The Commission has issued the enclosed Amendment No. 79 to Facility Operating License No. DPR-56 for the Peach Bottom Atomic Power Station, Unit No. 3. This amendment consists of changes to the Technical Specifications (TSs) in response to your applications dated September 30, 1980 and March 30, 1981, as supplemented April 24, June 30 and July 15, 1981.

PEACH BOTTOM ATOMIC POWER STATION, UNIT NO. 3

AMENDMENT TO FACILITY OPERATING LICENSE

Amendment No. 79
License No. DPR-56

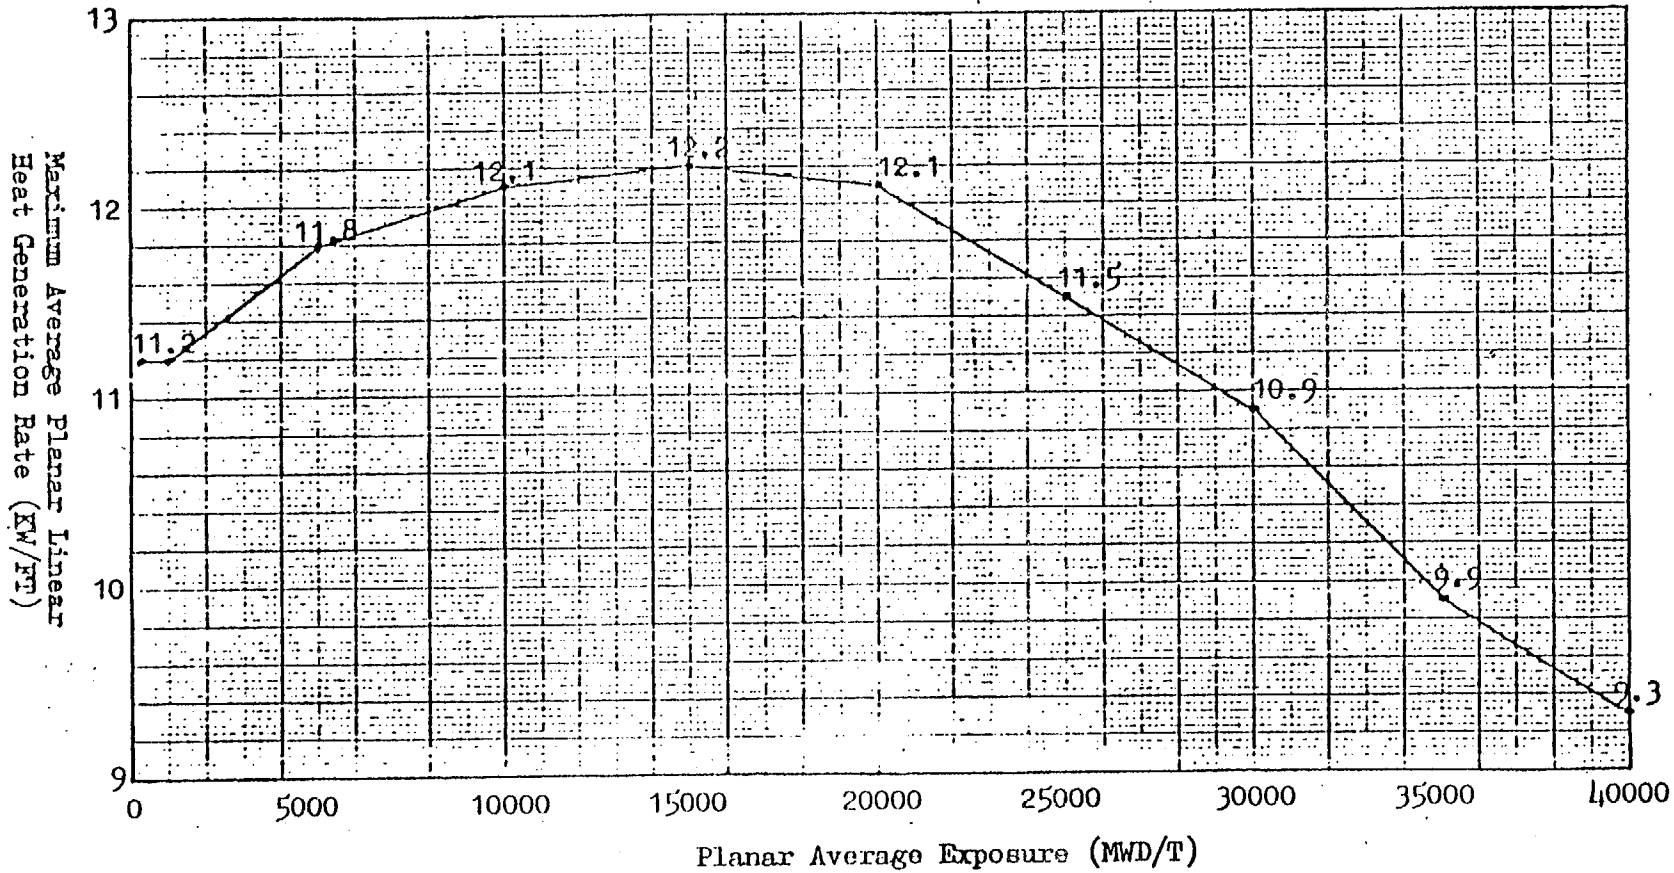
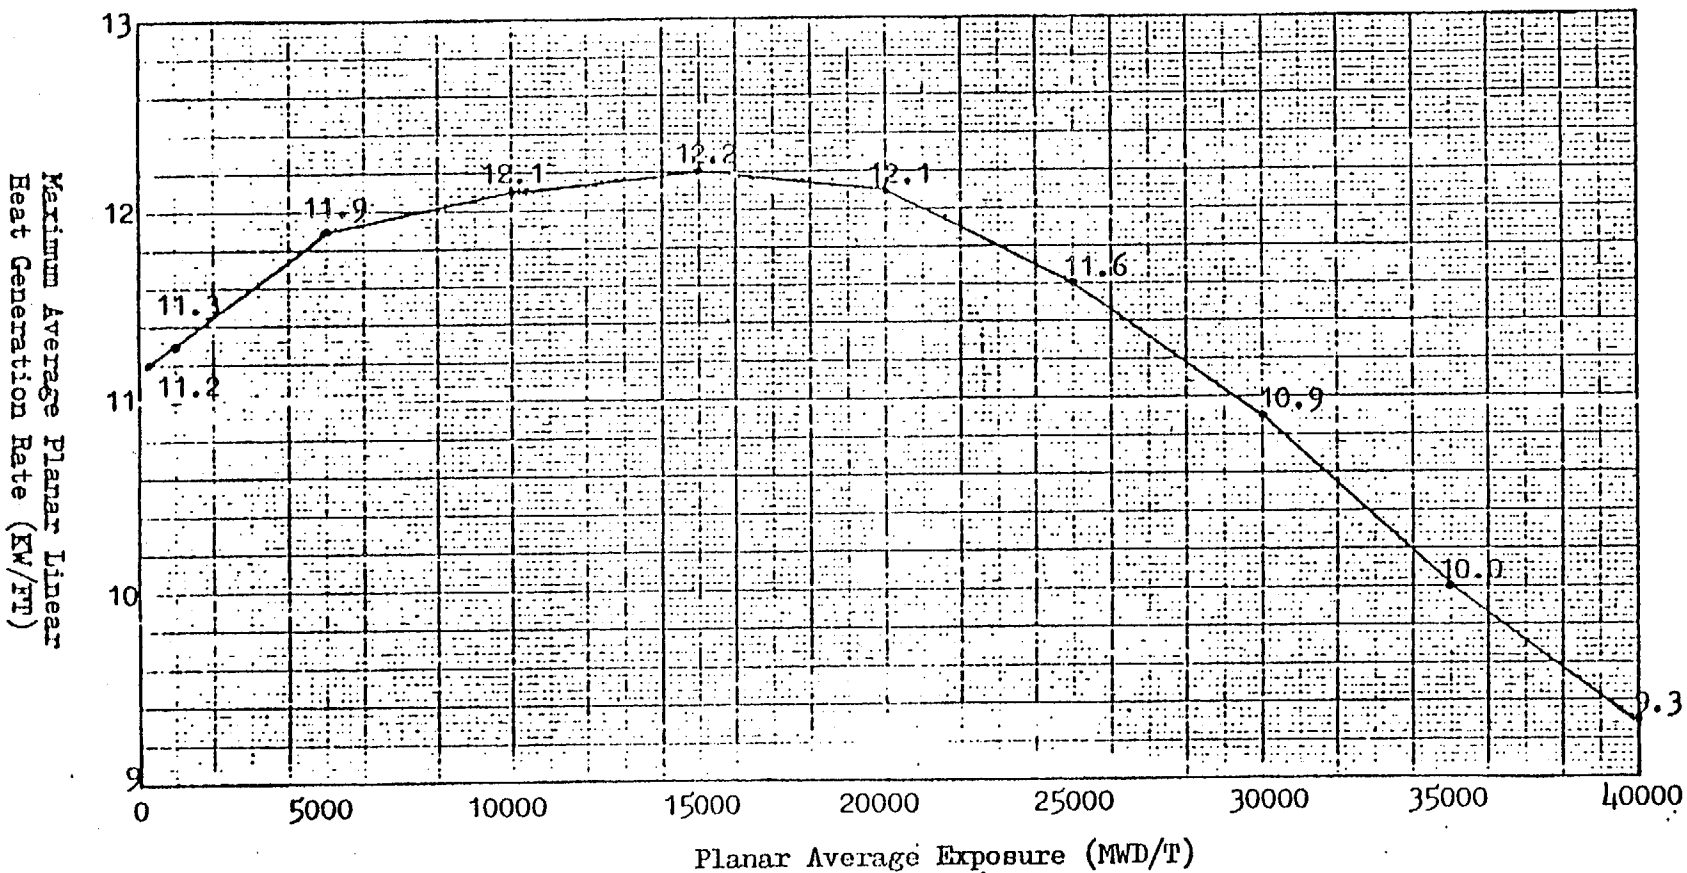
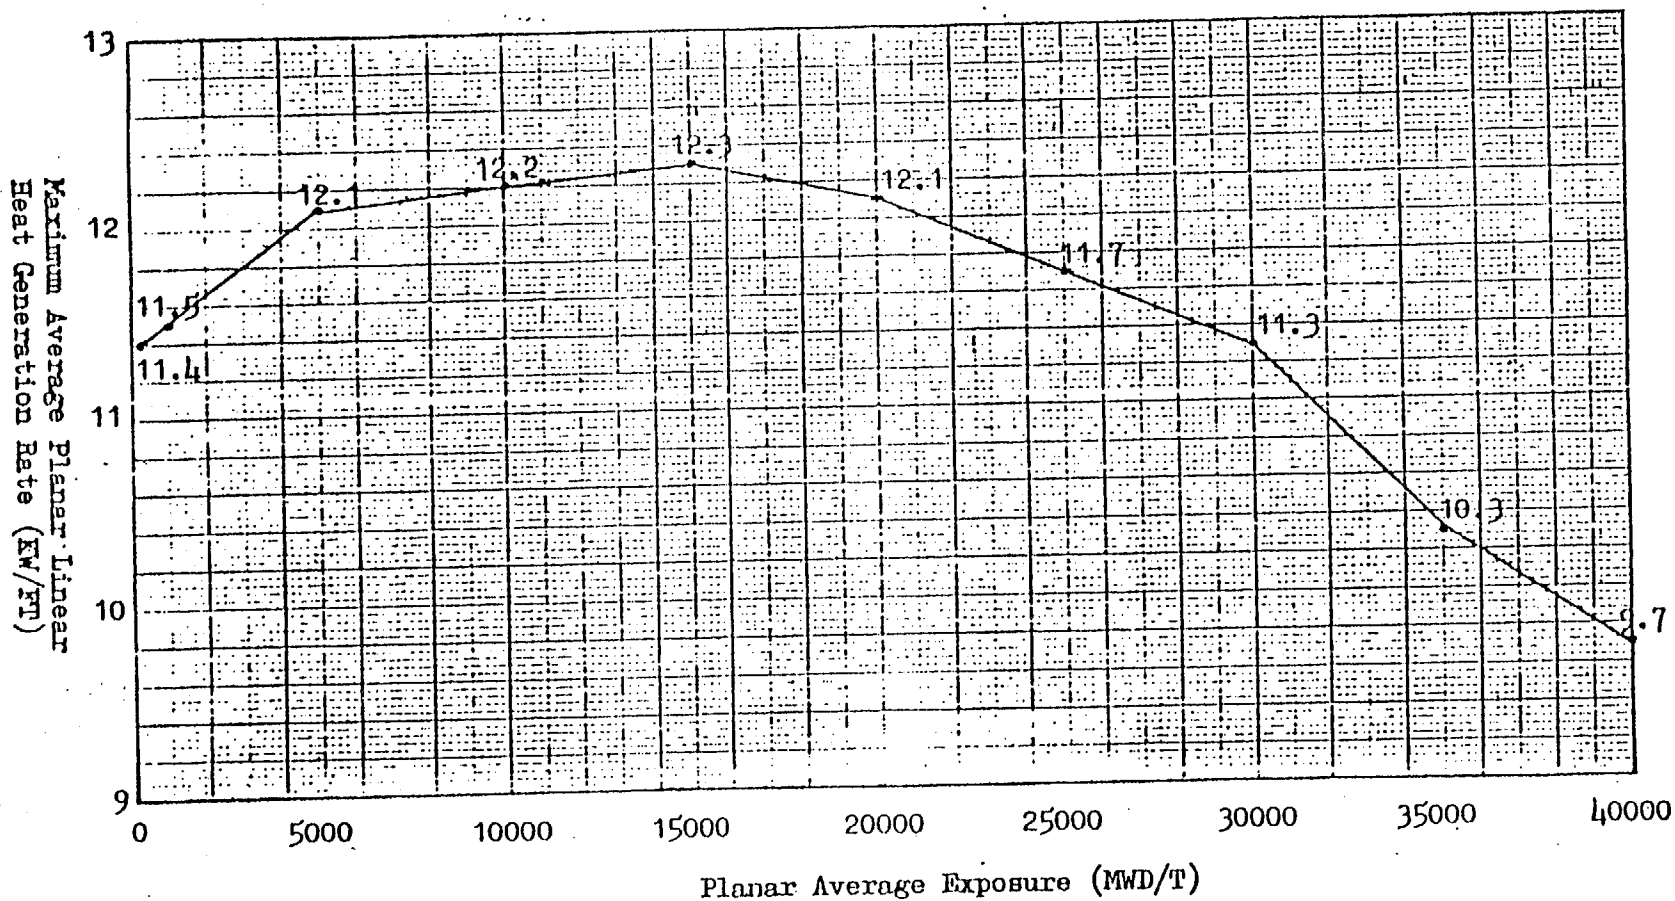
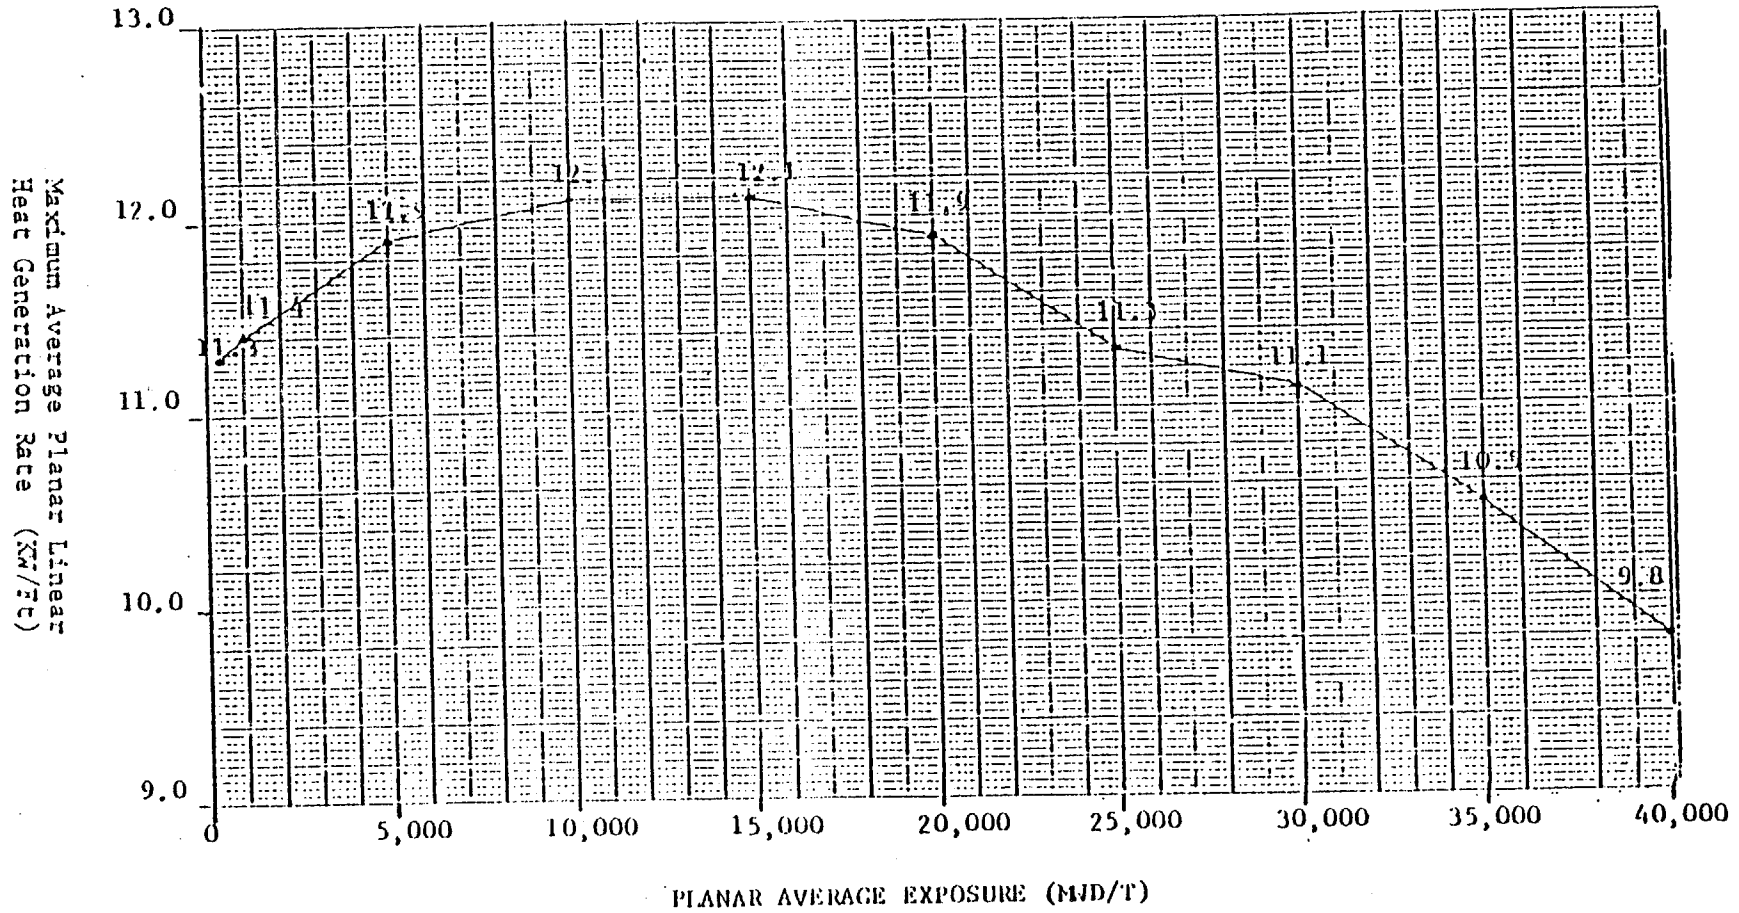
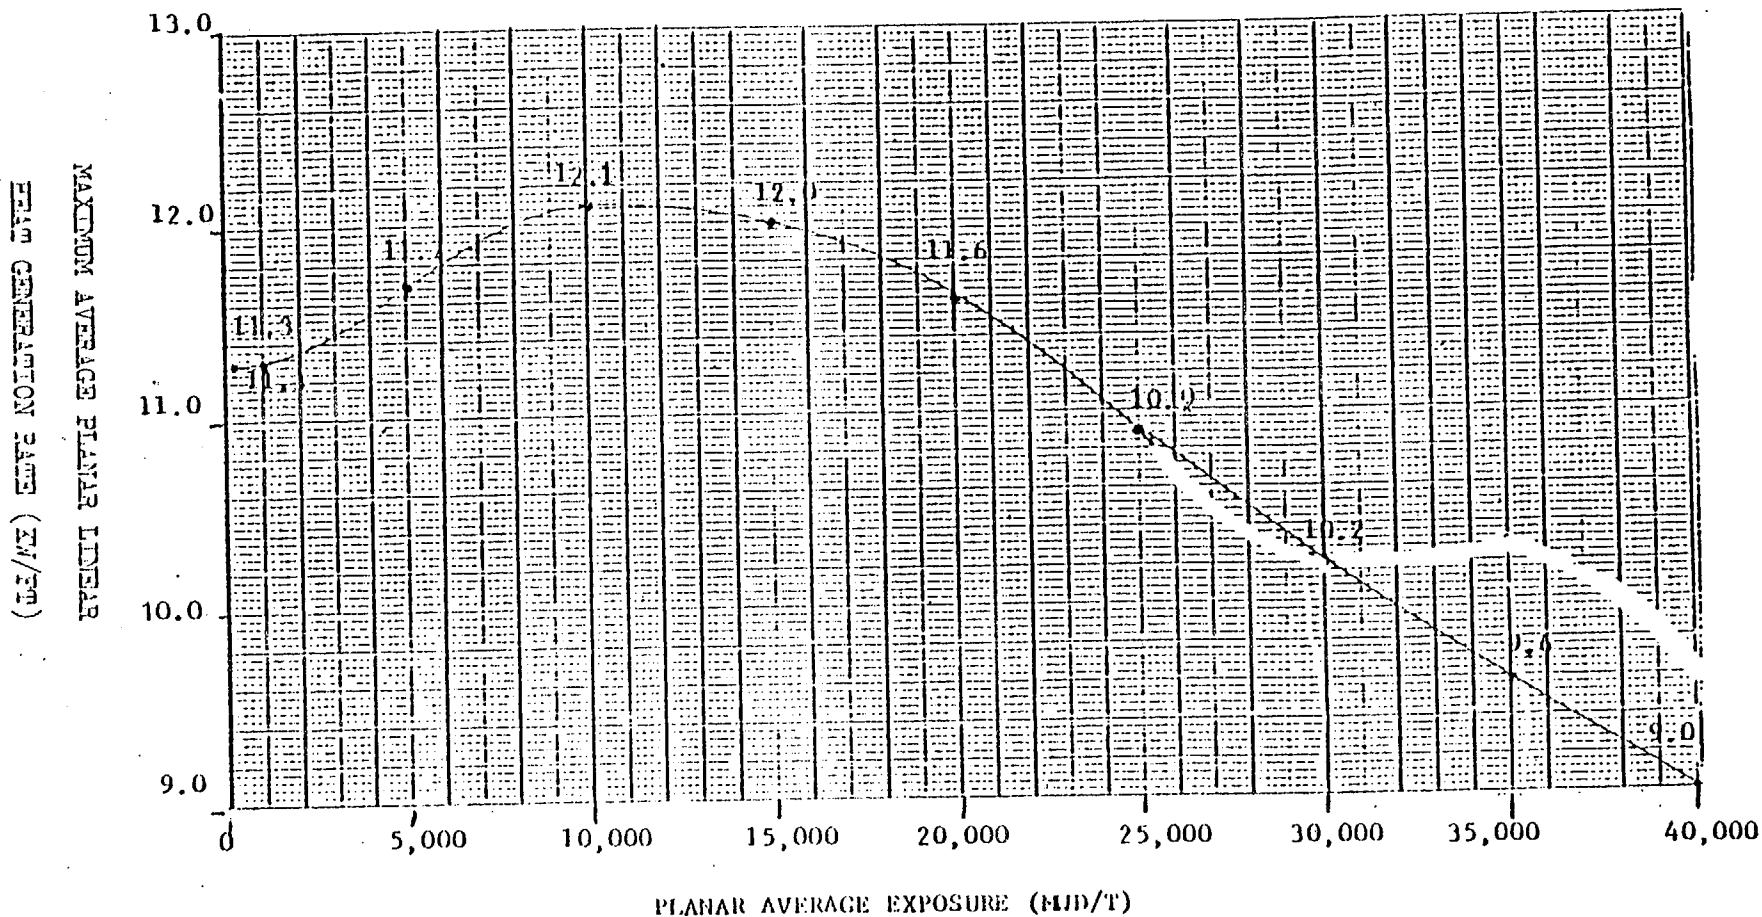
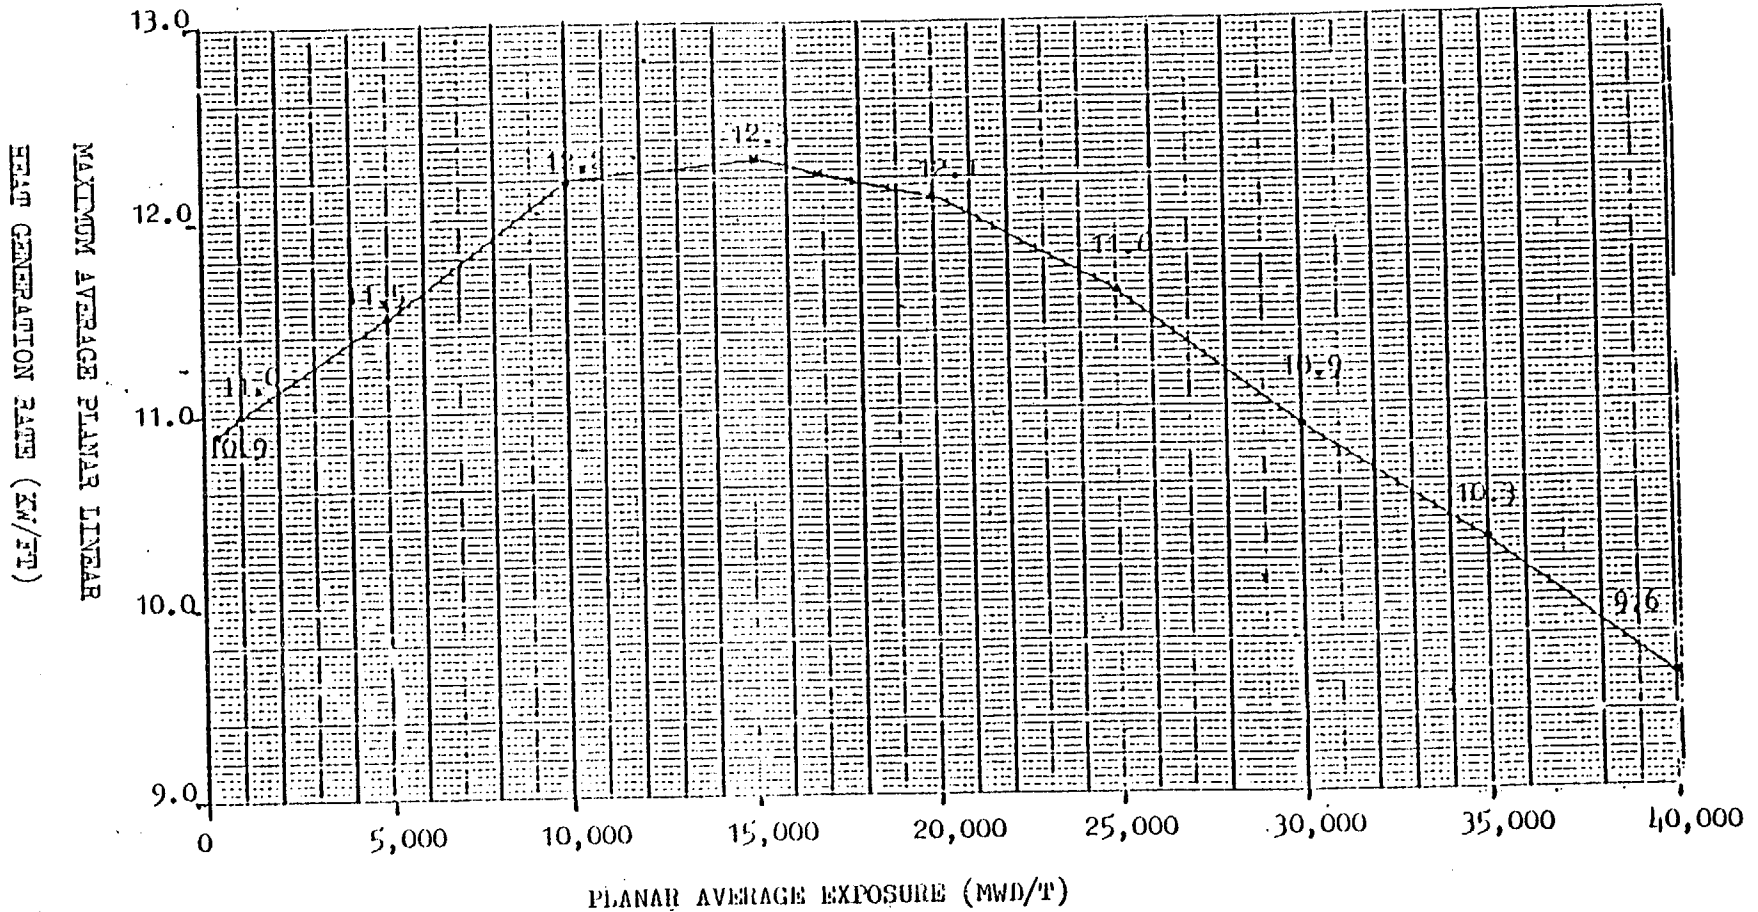
To ensure that the environmental considerations in 10 CFR 51 are evaluated, if MAPLHGR limits are extended in the future, we have, with the licensee's concurrence, added a note to the TS Figures related to MAPLHGR limits, stating the requirement of 10 CFR 51.20.
